Re: Novus Build-to-Rent – 39-43 Hassall Street, Parramatta Request for Information

Attachment 1: Detailed Response to the IPC's Request for Information

■ **Figure 6-1: Peak flood levels for Option 2(f) in the 100 year ARI 2 hour event**

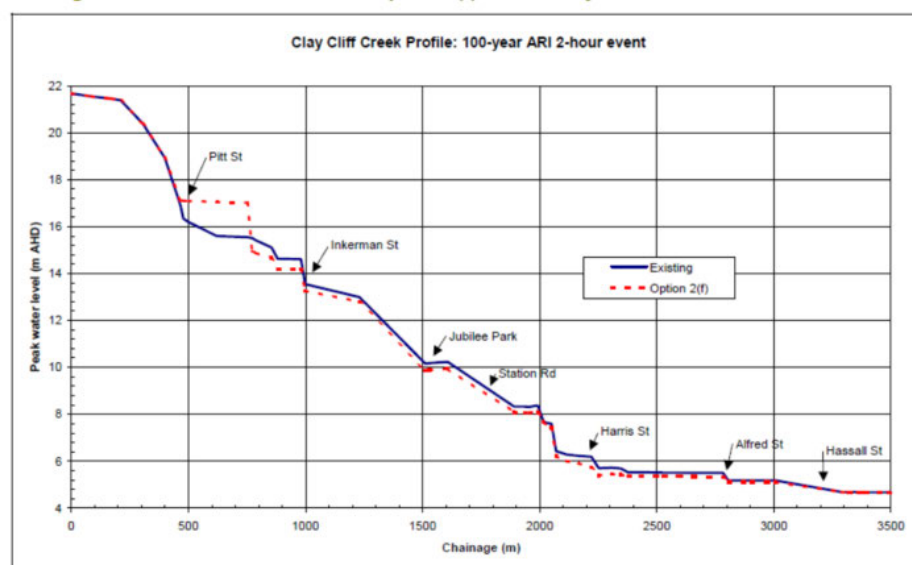
- a. A review of the flood assessment documentation to reflect the adoption of the recommended greater flow rate for design and recommended 1% AEP flood event level (15% blockage and climate change scenario).

- The *Lower Parramatta River Floodplain Risk Management Study and Plan* prepared for Parramatta City Council by SKM in August 2005 (SKM, 2005b) assessed the attenuating effects of the [then] proposed Ollie Webb Reserve detention basin and included a long section which shows that the peak flood level on the upstream face of the Harris Street bridge would reduce to below 6.0 m AHD with the basin in operation, **Refer to Figure 6-1 below**. The detention basin was subsequently constructed and therefore the flood modelling undertaken as part of SKM, 2005b demonstrates that Council's adopted flood level data are not based on contemporaneous catchment conditions and may be overestimating site flood levels by hundreds of millimetres.

Condition is not acceptable.

The flood assessment documentation already tests for this scenario. On the 1% AEP (with 15% blockage and climate change scenario as per Table 1 of MS's Flood Risk Assessment (June 2023)) the flood levels range from 6.30m AHD to 6.49m AHD across the site and importantly do not exceed the proposal's 6.70m AHD passive mitigation measures associated with the basement and the proposal's 7.0 m AHD finished ground floor level. Furthermore, the flood assessment documentation estimates that it takes a probability of about 1 in 2,300 before the driveway ramp crest is overtopped (6.70m AHD) by riverine floodwaters and of about 1 in 5,000 before the ground floor floods (7.00m AHD). The PMF has been estimated as a probability of 1 in 1,000,000.

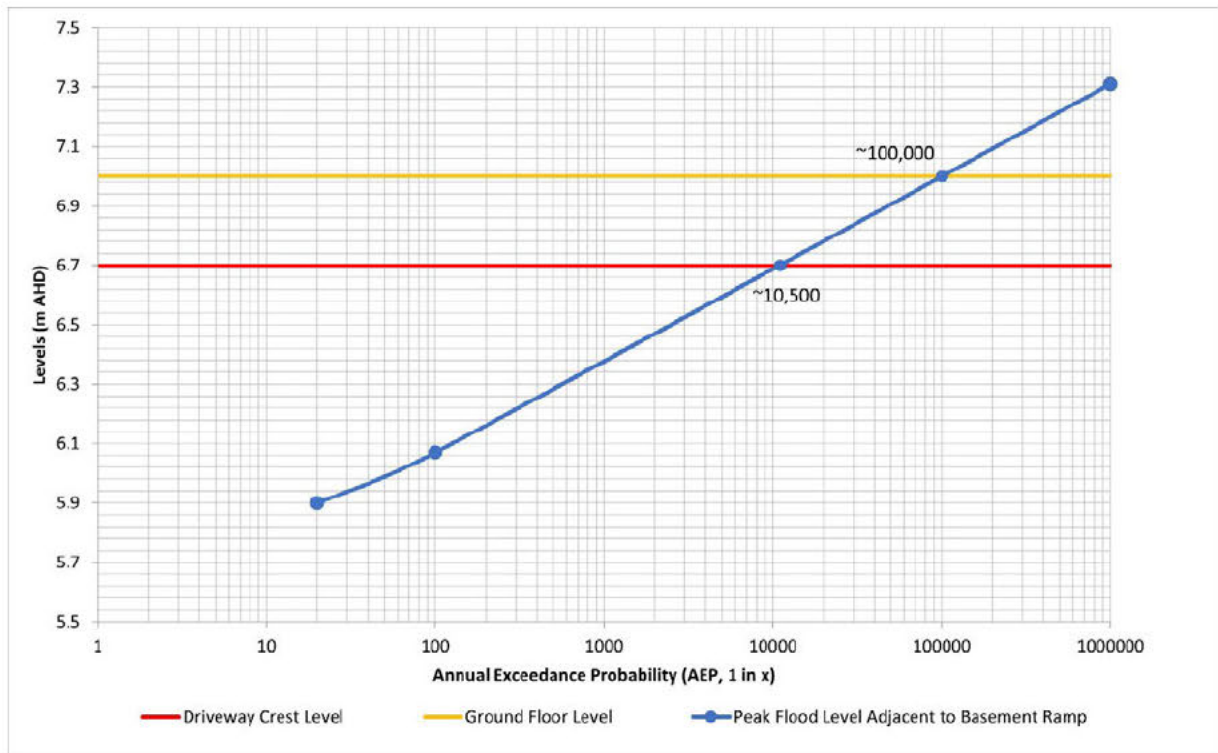
To determine the probability of combined creek and overland floods that would overtop the driveway ramp crest of ground floor, the figure below plots the 5% AEP, 1% AEP and PMF creek and overland events on a log linear graph using levels adjacent to the driveway ramp crest. The figure suggests that the basement ramp crest level of 6.70m AHD has about a 1 in 10,500 chance of being exceeded by combined overland and creek flooding and the ground floor level of 7.0m AHD has a 1 in 100,000 chance of being exceeded.

The higher of these probabilities should be considered in flood risk assessment. Therefore, there is a 1 in 2,300 chance of the level of the basement ramp crest being reached or exceeded in any given year. Although a combined creek and overland event could have a much higher rate of rise than riverine flooding, a creek and overland flood with a much lower AEP would be needed to reach the basement ramp crest.
